2020 Corvette: Service Bulletin:: #20-NA-179: Malfunction Indicator Lamp (MIL) Illuminated - DTCs P0521 and/or P06DD Set - (Oct 23, 2020)

Subject:				Malfunction Indicator Lamp (MIL) Illuminated – DTCs P0521 and/or P06DD Set			
Brand:	Model:	Model Year:		VIN Breakpoint:		Engine:	Transmission:
		from	to	from	to		
Chevrolet	Corvette	2020	2020	SORP	September 10, 2020	6.2L (LT2)	—

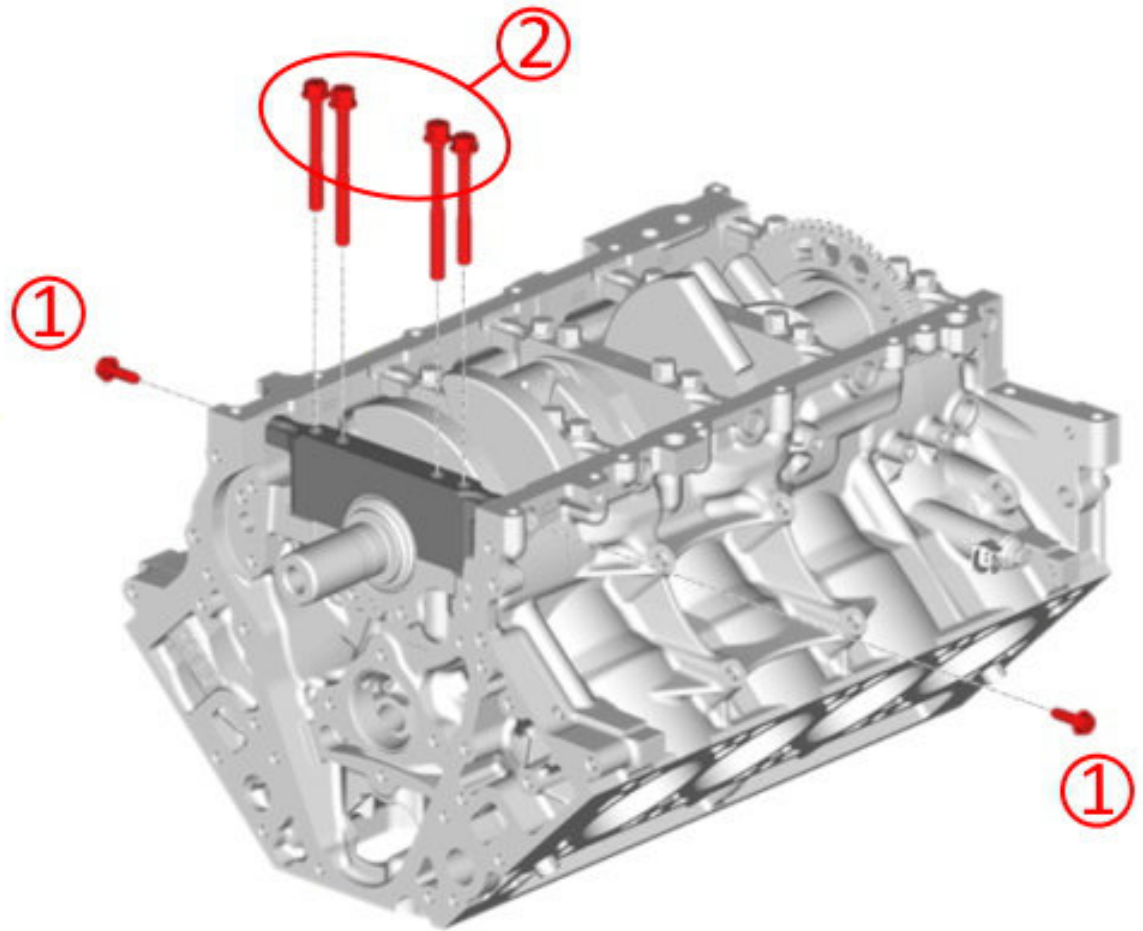
If P0521 and P06DD DTCs are present, then a redesigned oil pressure control valve retainer clip (1) may be necessary. Refer to the Service Procedure section below.

1. Remove the engine oil pan. Refer to *Oil Pan Replacement* in SI.

Note: The generator may need to be repositioned to gain access to the main cap side bolts.

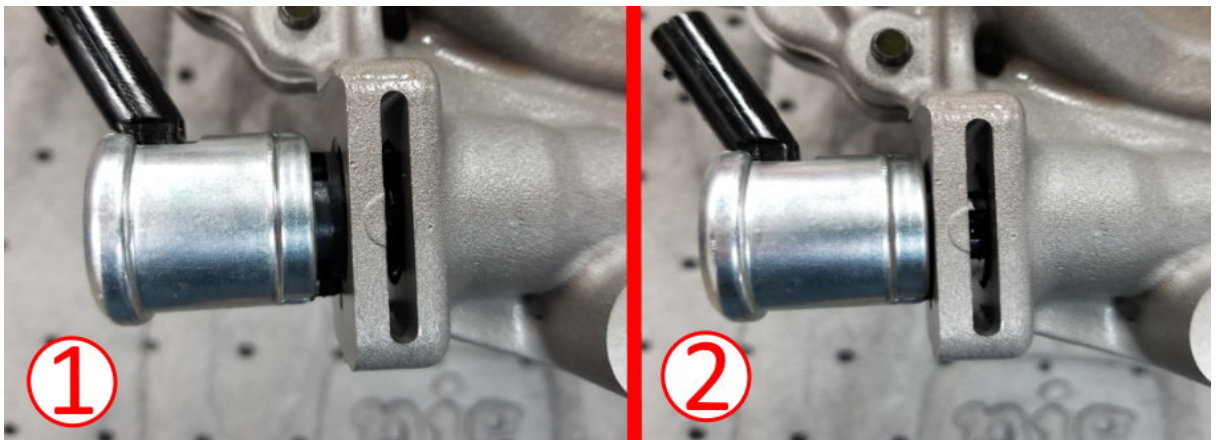
1. Remove the main cap side bolts (1).

Important: When removing the main bearing cap be careful not to

damage the main bearing or journal surface of the crankshaft. Please set the main bearing cap in a safe place so no debris or damage could occur.

1. Remove and discard the bolts (2) that secure the #1 main bearing cap.

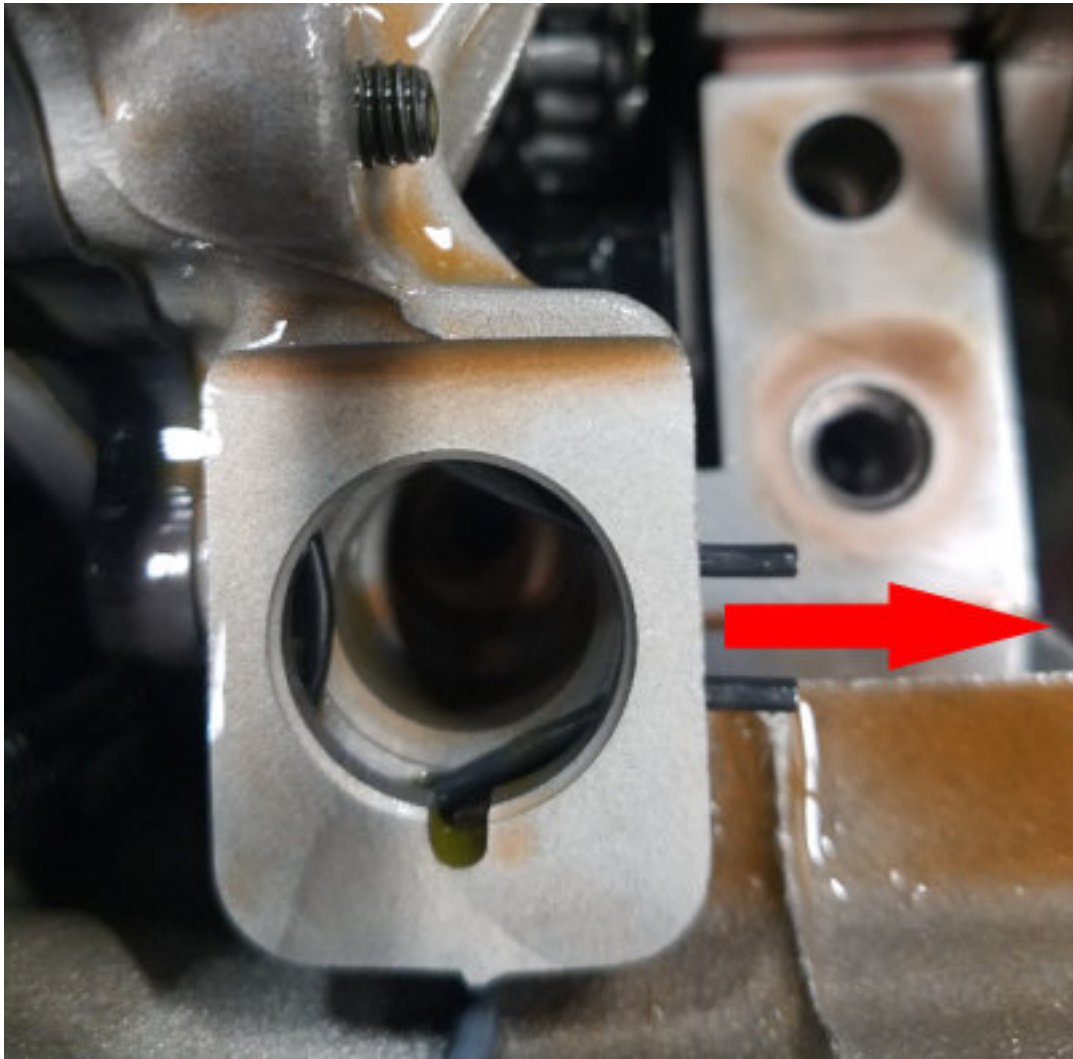
1. Inspect the OCV:
 - If you find this oil pressure control valve dislodged (1), it will be necessary to install a redesigned oil control valve retainer.
- Disconnect the oil pressure control valve electrical connector and position aside.

Note: Remove the existing oil pressure control valve retainer by pulling towards the rear and discard. You will be installing a newly designed retainer during installation.

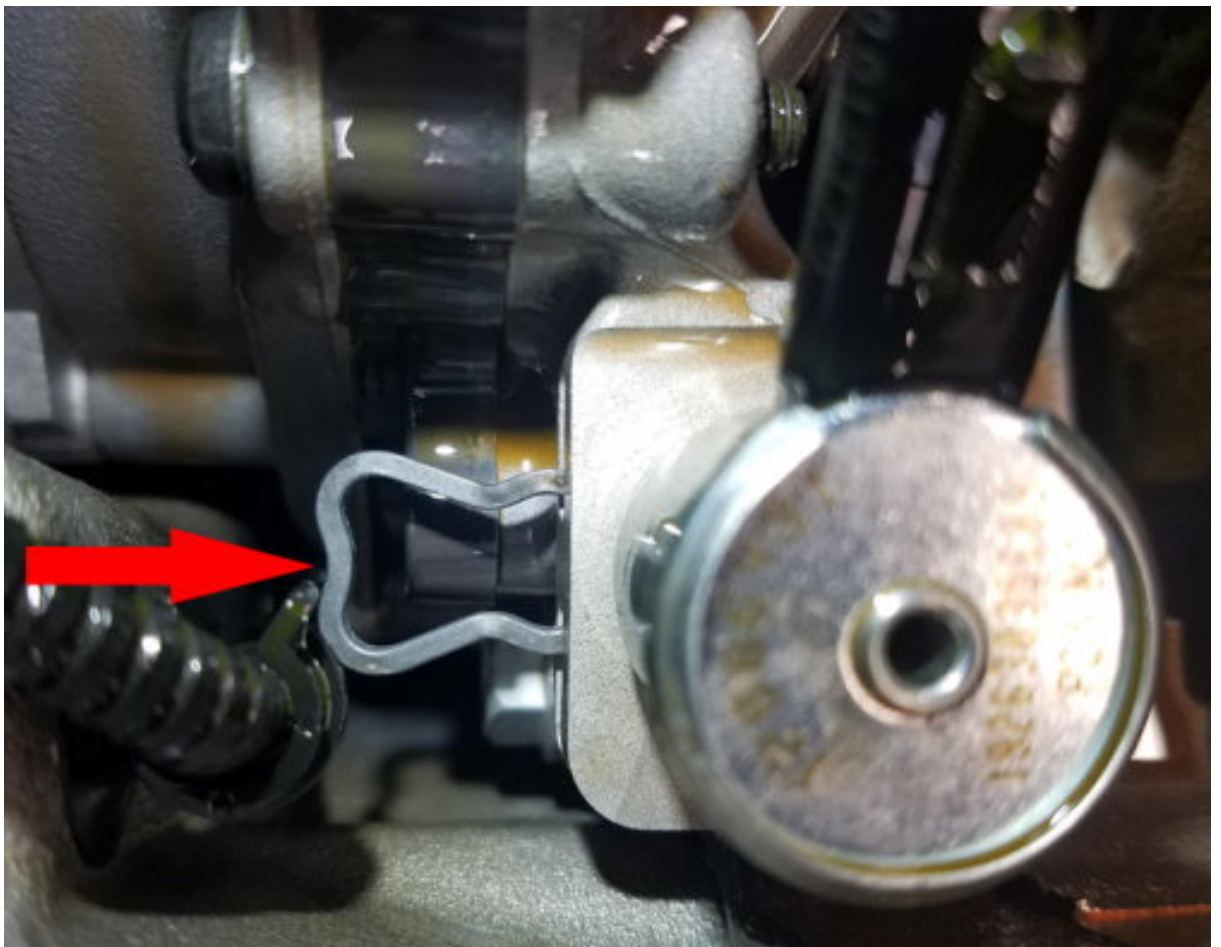
1. Push in the retainer and remove the oil pressure control valve and set aside.
2. Once the retainer is removed, inspect the oil pressure control valve for any signs of damage and ensure the O-ring is not cut.
 - Apply a small amount of clean engine oil to the pressure control valve and reinstall ensuring it is seated correctly.

Important: Do not use any tools to tap the pressure control valve into place. Only install the pressure control valve by pushing on the body of the valve by hand.

1. Install the new retainer from the front of engine towards the rear as shown in the graphic above.

1. When the retainer is installed, there should be about 2 to 3 mm of clearance between the retainer and the oil pump body as shown above.
